TECHNICAL NOTE

Bureau of Land Management U.S. DEPARTMENT OF THE INTERIOR

FORD TRUCKS - PARTS AND SERVICE RECOMMENDATIONS, part I

Figure 1

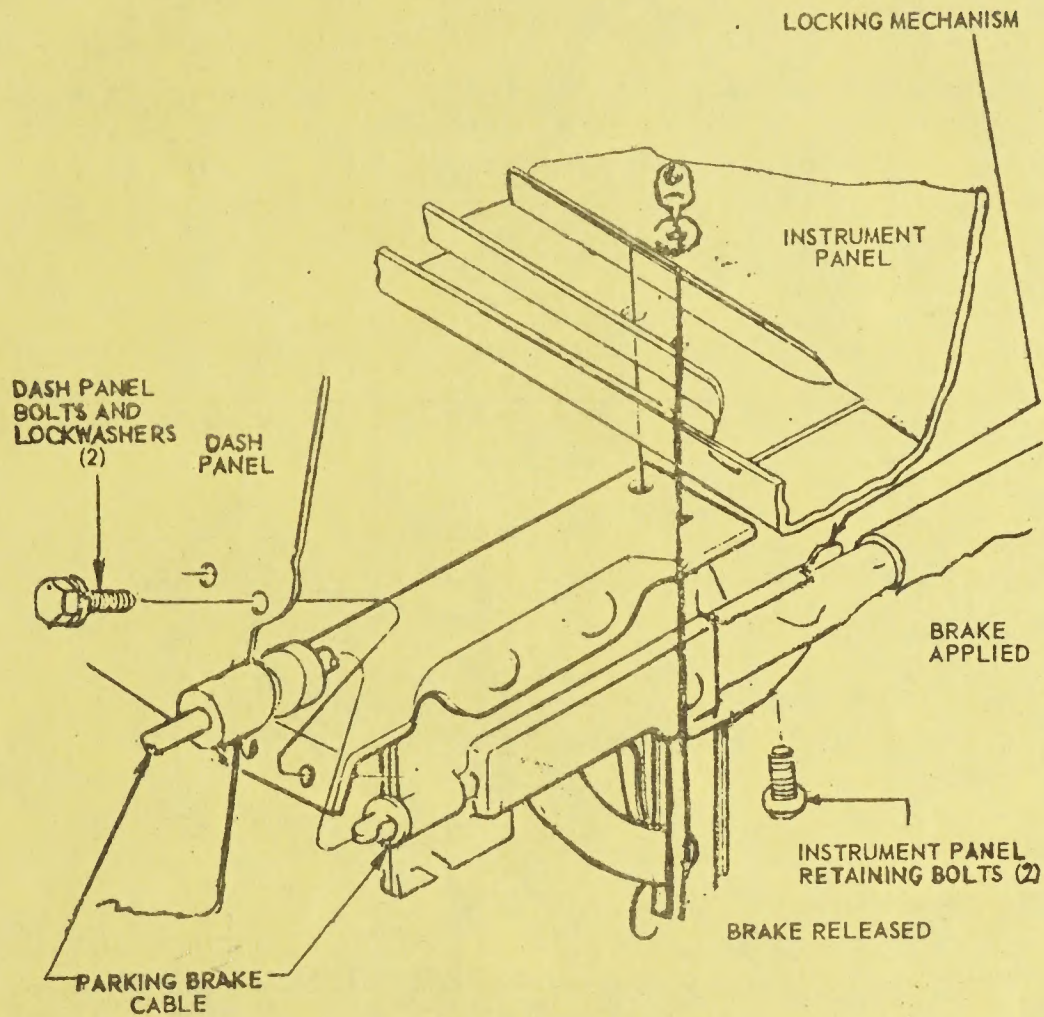
OPERATING INSTRUCTIONS: Application - Grasp handle of lever and pull upward (without applying pressure to the lock mechanism until the lever travels to the over-center full on position, horizontal). Figure 1 Release - Depress the lock release with the left hand thumb. Push lever downward to the vertical position. Figure 2.

Figure 2

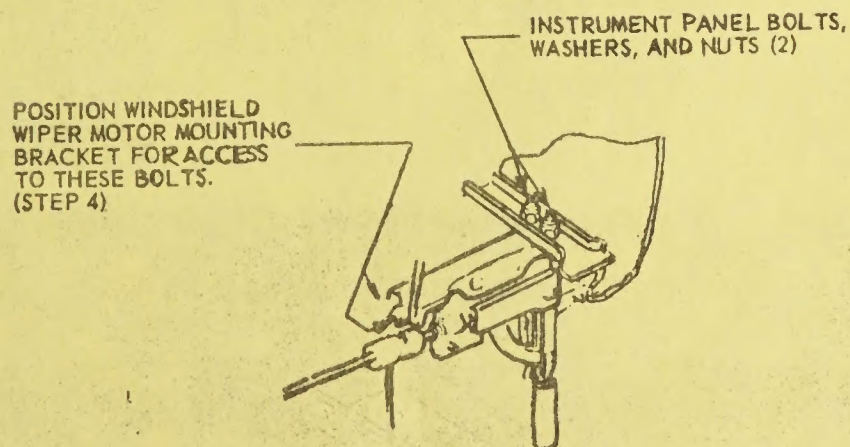
CAUTION: Do not force the lever down without depressing the lock release; otherwise the lock will become damaged, rendering it ineffective in the applied position.

Figure 3

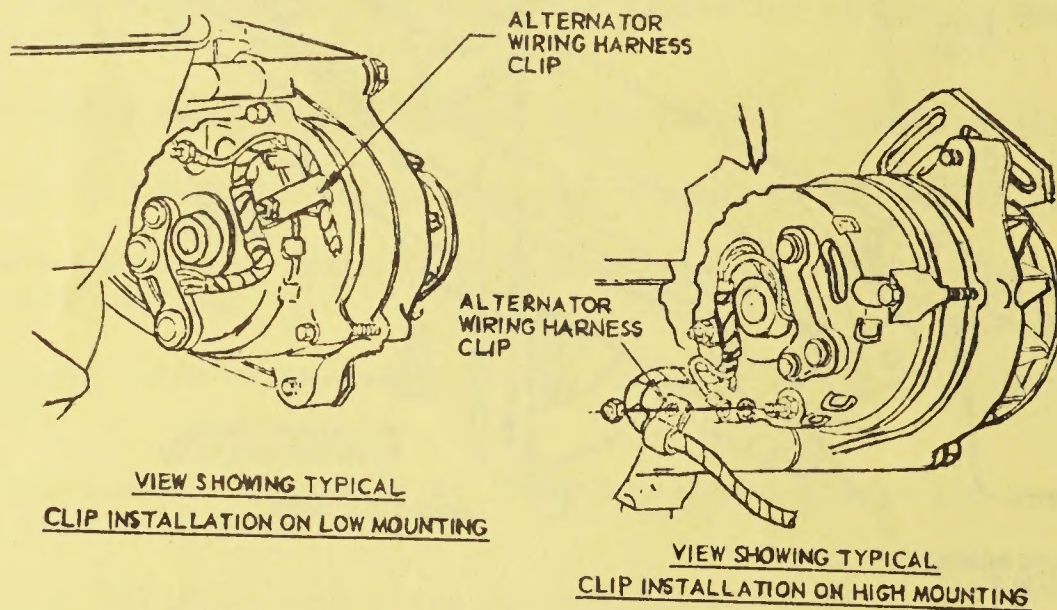
A plastic coated metal clip is used to hold the alternator wiring harness to the alternator (See Figure 3). If the plastic coating does not satisfactorily cover the edges of the clip, it is possible for the wiring harness to become chafed and shorted on the clip.

During vehicle predelivery inspect the alternator harness clip to assure that it is adequately coated and is not cutting into the alternator harness. If clip replacement is required, use new nylon clip, Part No. 376188-S.
